GISBORNE WASTEWATER NETWORK – OVERFLOW DISCHARGES: REGULATORY REF: DW-2020-109732-00/WD-2020-109733-00

Further S92 Response 21 April 2021

Attachment A: Flow Monitoring Points and Network Maps

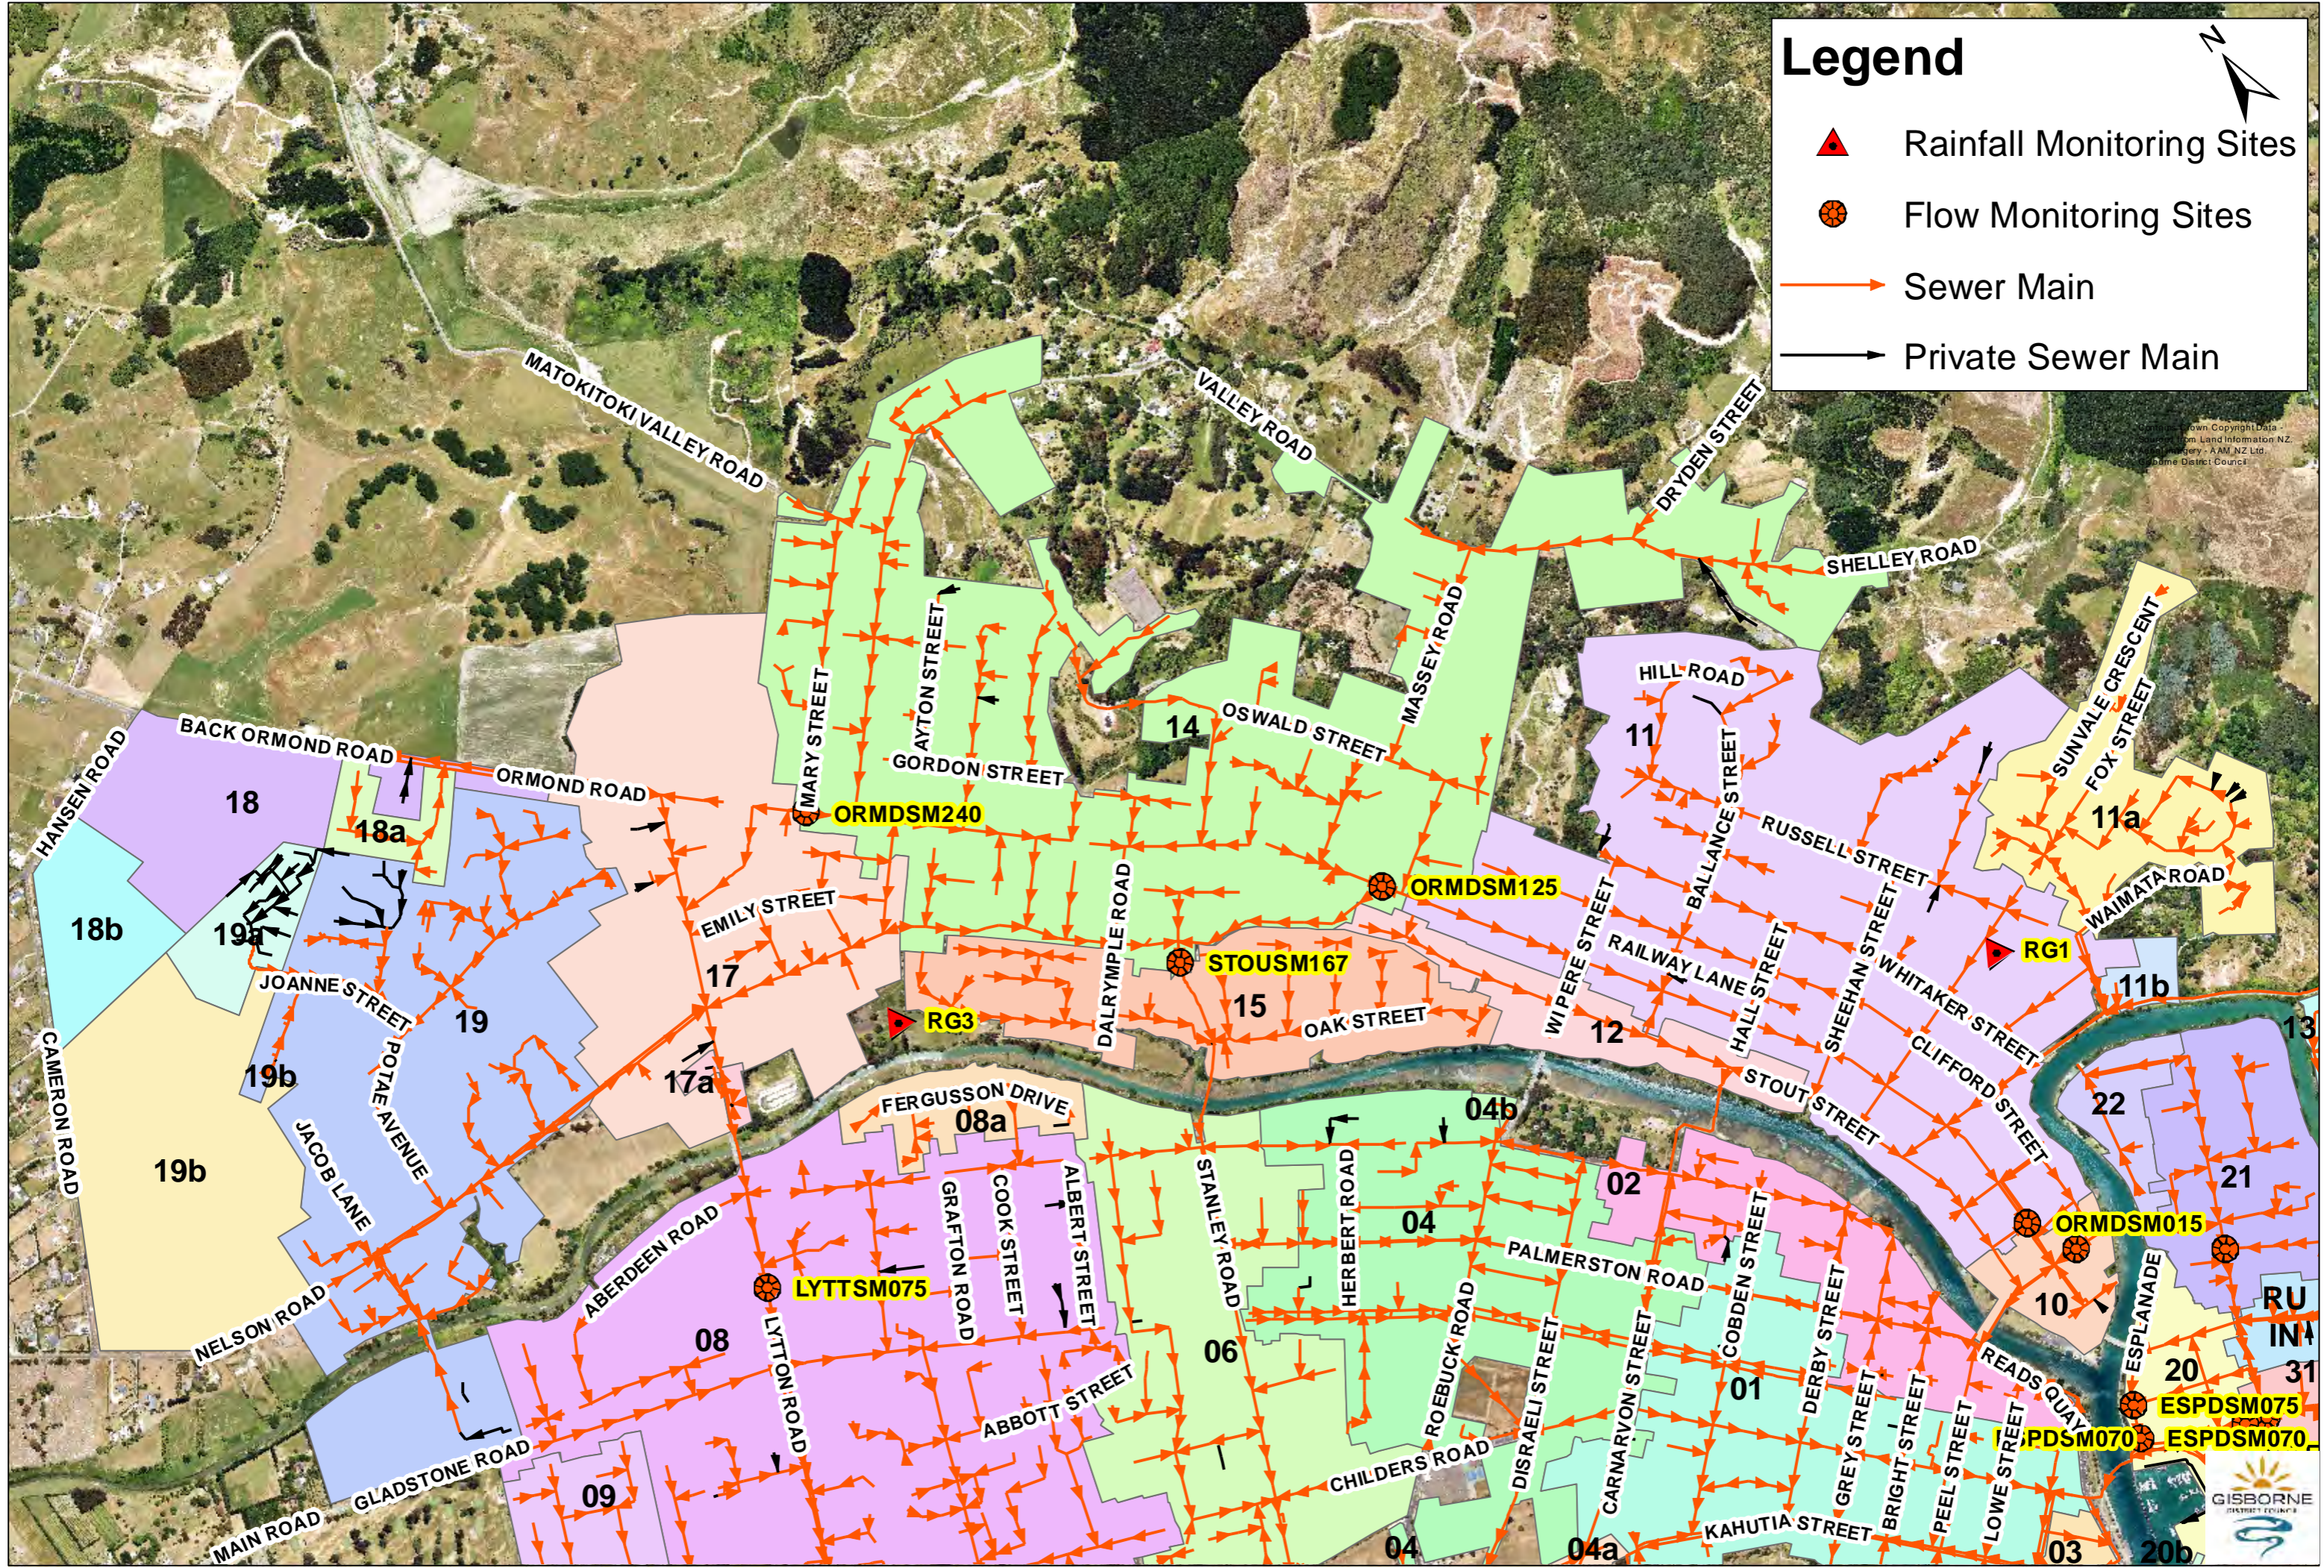
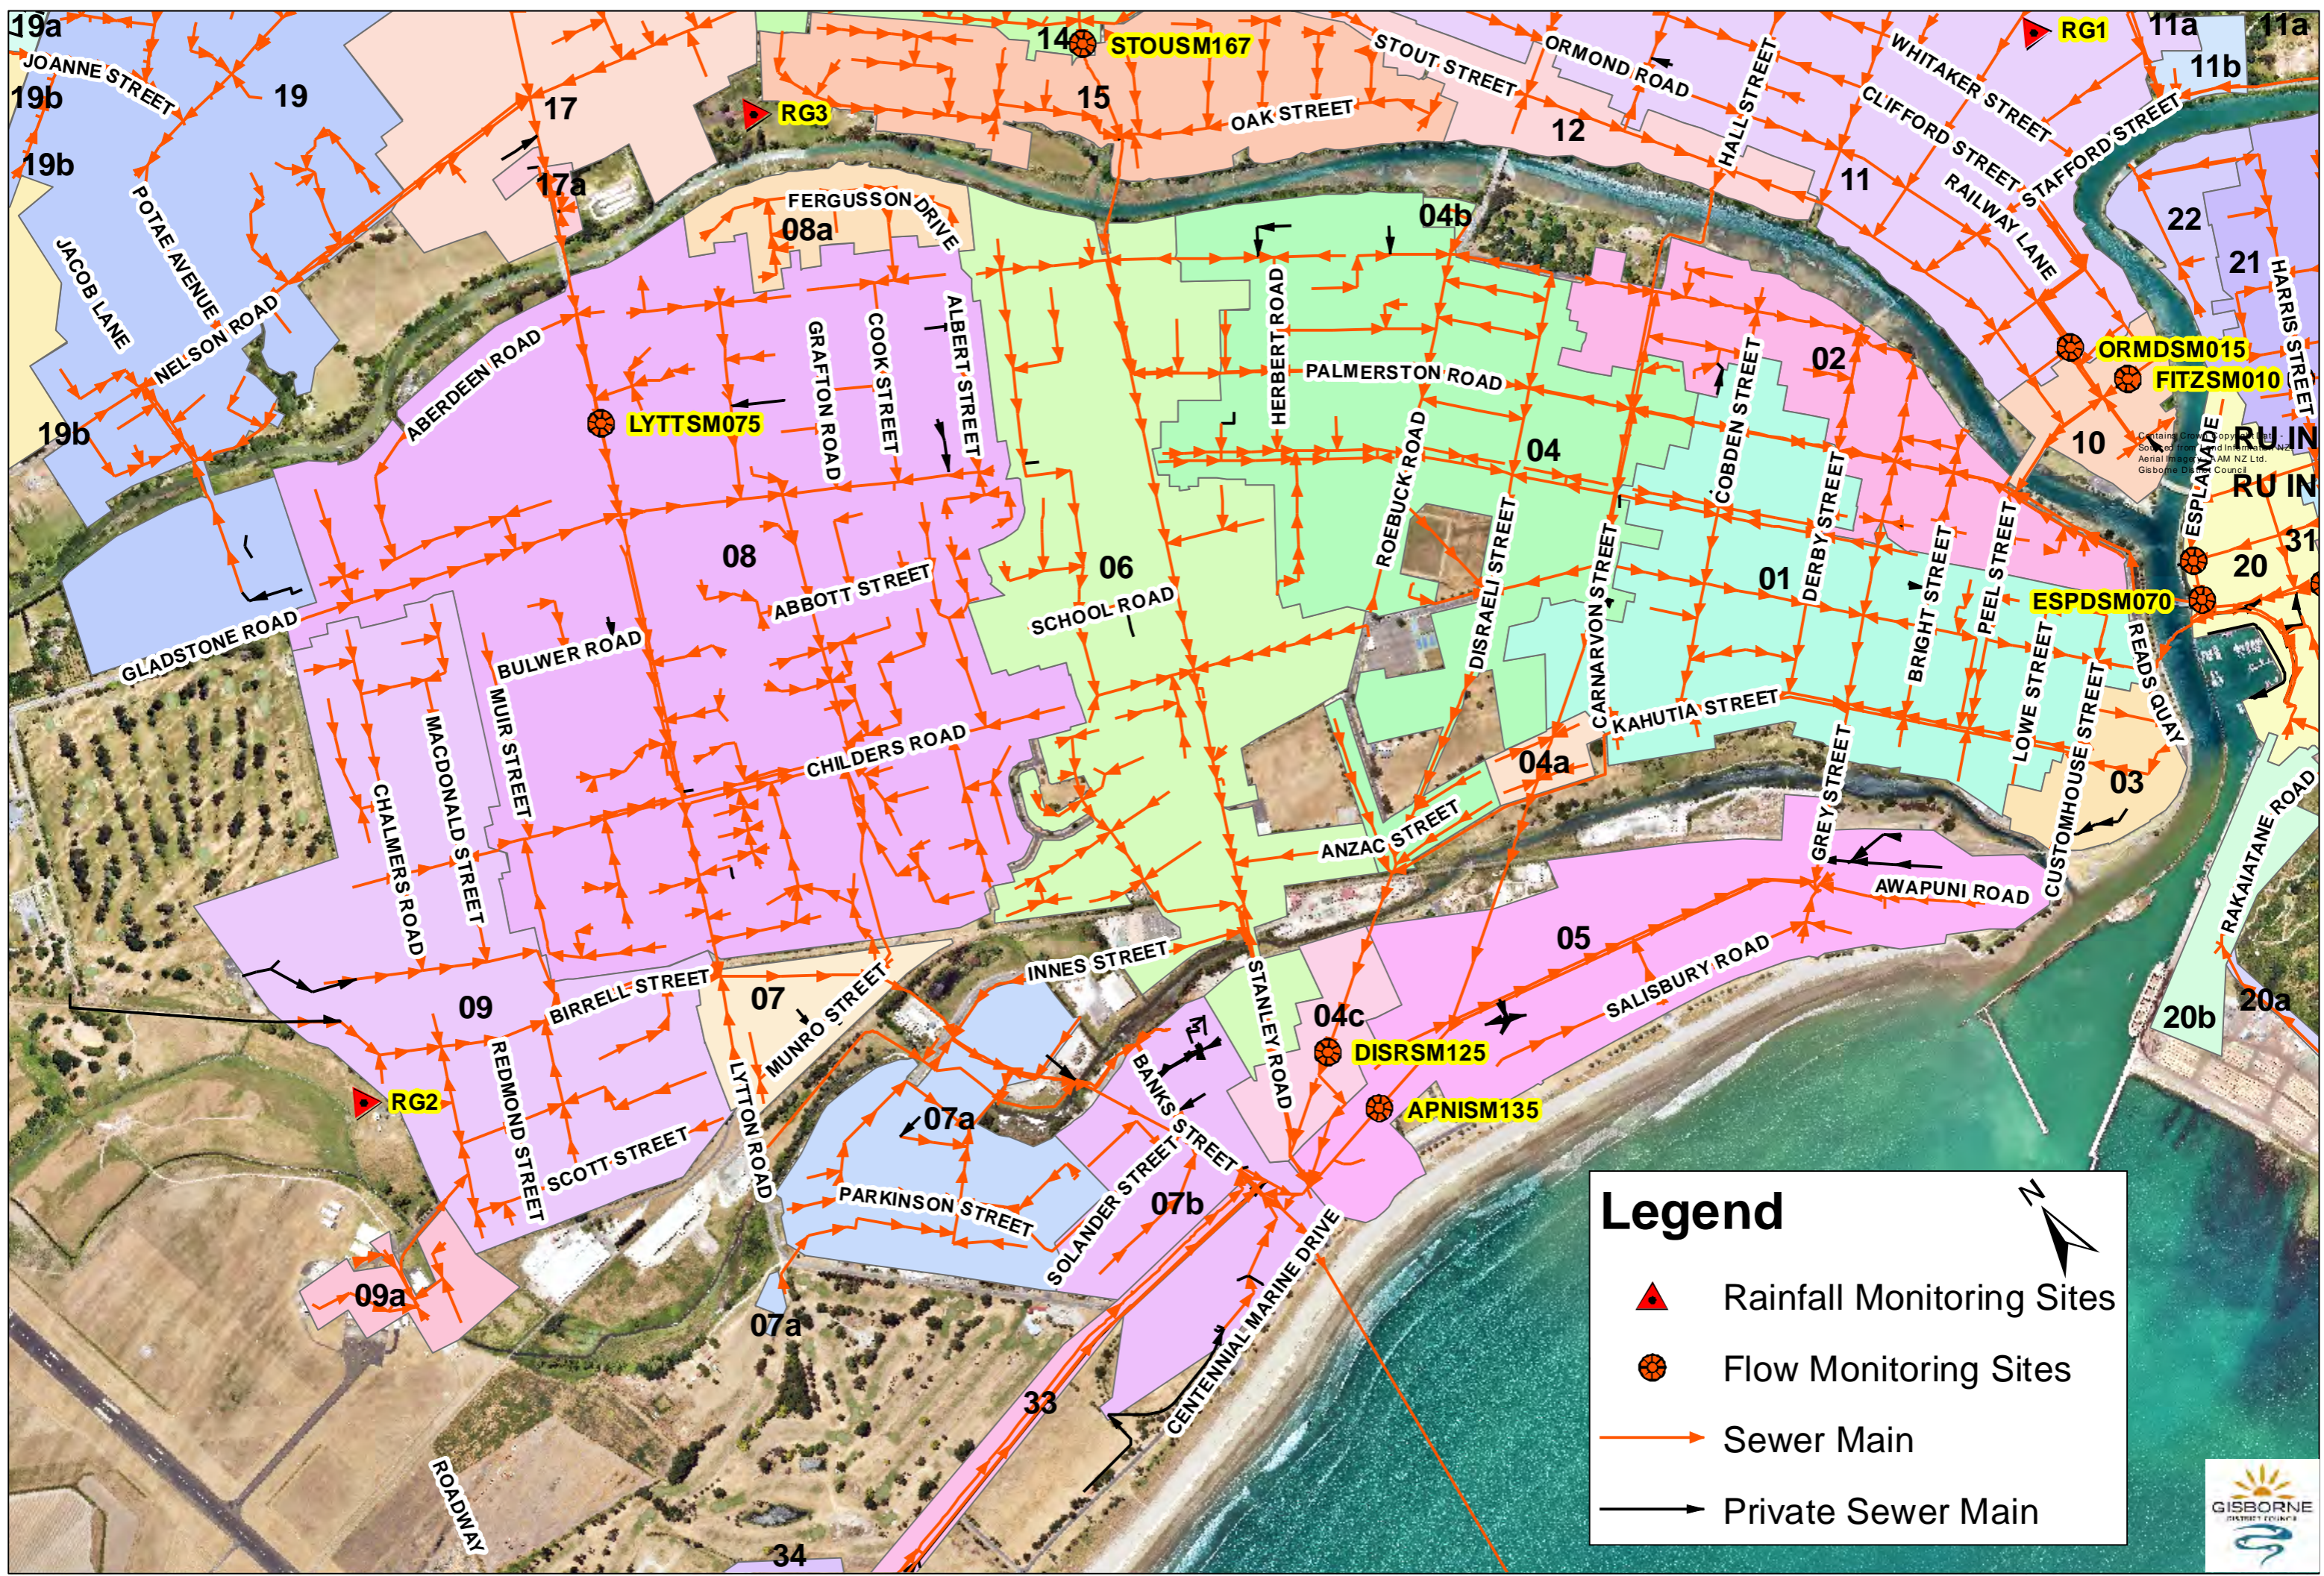
<p>(ii) In the response BECA refer to the following “The flow monitoring undertaken for model calibration provided flow/time graphs which show that the network is dealing with significant direct inflow (fast response), then rain derived infiltration followed by groundwater infiltration - which are consistent with the Water NZ manual”:</p>	
<p>a. Can the applicant provide a map/schematic showing the location of the gauging points and associated</p>	<p>Maps showing the locations of the monitoring points, together with the contributing catchment and network are provided as Attachment A.</p>

<p>upstream wastewater network including pump stations and reference (from the Mott Macdonald gauging report) which locations/hydrographs one(s) show the fast response to direct inflow?</p>	<p>We have also extracted flow monitoring information from the Mott Macdonald report for June 2014 (Attachment B) to facilitate review of the network flow monitoring across the monitoring sites. As can be seen from this extract, all of the monitoring sites show rapid response to heavy rainfall. Some sites to the south of the Taruheru River (eg APNISM135, DISRSM125 and LYTTSM075) also show the influence of overflow valves being opened from 11 to 12 June 2014.</p>
<p>b. Can the applicant provide a map/schematic that show areas of known property flooding referenced in the original application, page 223, see Figure 3-2 from the CH2M Beca Modelling Report, 2017. How does this compare to the nodes identified as flooding in the 2yr-ARI map (Figure B2) in the Beca modelling report.</p>	<p>A map showing indicative property ponding is provided below.</p> <p>The 'Ponding Likelihood' layer predicts where water is likely to pond on a property, based on a number of GIS layers that have been aggregated through a weighting process. These GIS layers include our stormwater flood model, depressions layer, and a Rain on Grid model.</p> <p>Ponding can be affected by many factors, e.g. fences on a property may divert flows, private stormwater sumps and pipes may drain areas, and soil conditions may allow for water to seep into the soil quicker than modelled. The data is also relevant to information available at a specific point in time, and things may have changed over time. Therefore, this layer is viewed as a guide only, as site conditions could be different.</p> <p>The modelled information is based on geospatial modelling, is for indicative purposes only. Council also uses records of actual flooding (surveys and Requests for Service received) and undertakes property inspections / investigations to validate whether or not there are actual effects, and whether or not stormwater drainage improvements (public or private) are required to mitigate the risk of ponding.</p> <p>The nodes identified in Figure B2 have been overlain on the Ponding Likelihood' layer. However, the location of property flooding in heavy rainfall will not necessarily correlate to the location of wastewater overflows from manholes.</p> <p>While property flooding is considered a primary cause of rainwater entering the wastewater system, properties that experience wastewater overflows will not necessarily also be the properties that experience rainwater flooding. Property</p>
